**P-W048302-JAB**

**ADDENDUM #4**

### **First Floor Renovation UML-Ponca City, Oklahoma**

**ADDENDUM NO. 3**

DOCUMENT	REFERENCE FROM	
ADDENDUM #3	A1.11	
DATE	SHEET NUMBER	REVISION NUMBER
DEC. 08, 2011	SK-1	
	SEQUENCE	
	1 OF 1	
REMARKS

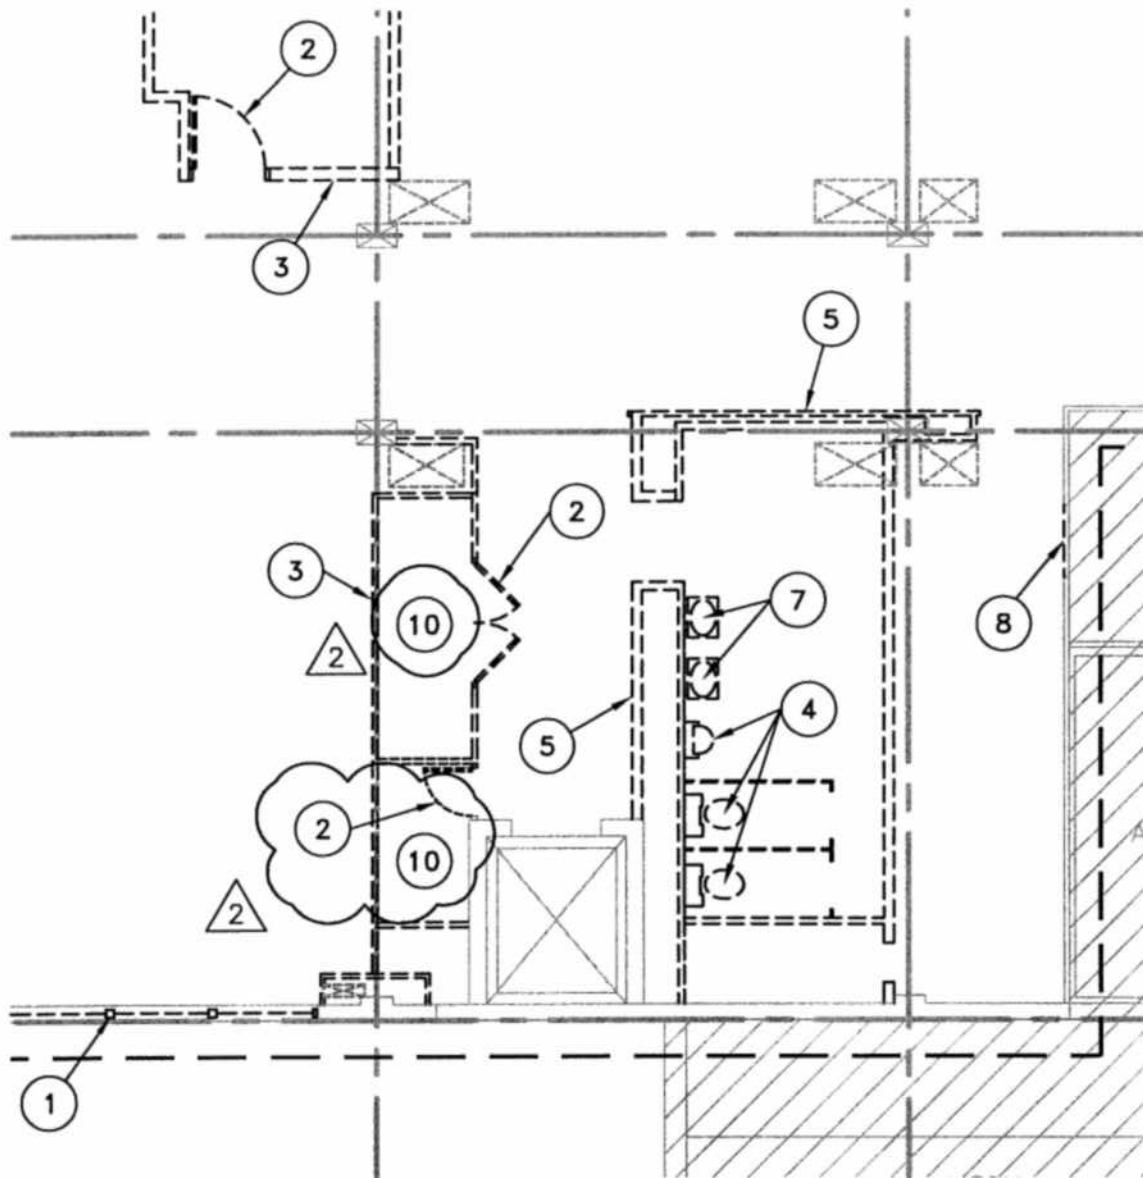
- a. Add keyed note 10 to read: "EXISTING ELECTRICAL/MECHANICAL EQUIPMENT SERVING DUMBWAITER TO REMAIN".
4. Reference: Demolition Plan on Sheet A1.11 "DEMOLITION PLAN"

- a. Add keyed note 10 to demolition plan as shown on sketch SK-1 attached hereto.
5. Reference: Equipment Legend on Sheet A2.11b "ENLARGED FLOOR PLAN – AREA B"
